REMARKS

Claims 1-6 are currently pending in the instant application, with claim 6 added by this Amendment. Claims 1 and 4 are independent. Reconsideration of this application, as amended, is respectfully requested.

Fig. 1

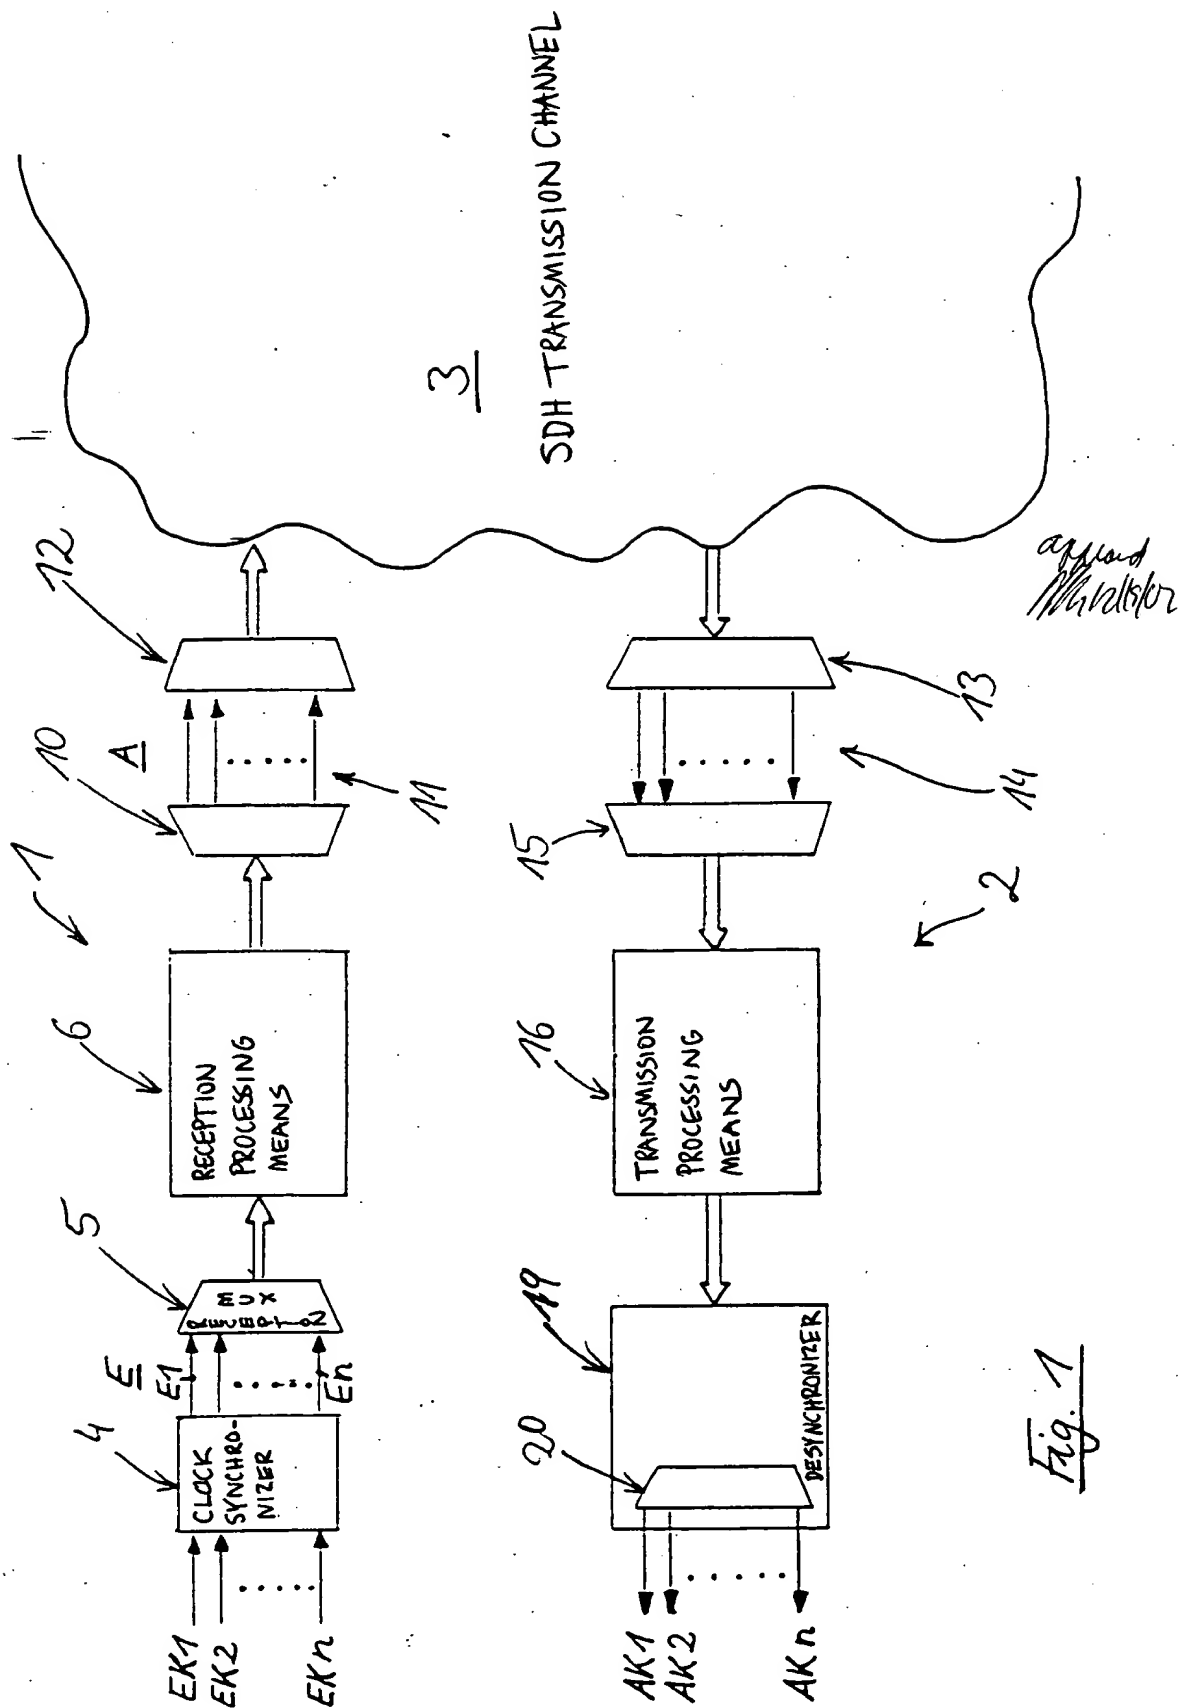
The drawings were objected to by the Examiner for failing to include required descriptive wording. A Drawing Change Authorization Request along with proposed drawing changes to Figs. 1-5 and 7 shown in red are included herewith. Formal drawings will be submitted at a later date. Applicant submits that the objection to the drawings has been overcome and accordingly should be withdrawn.
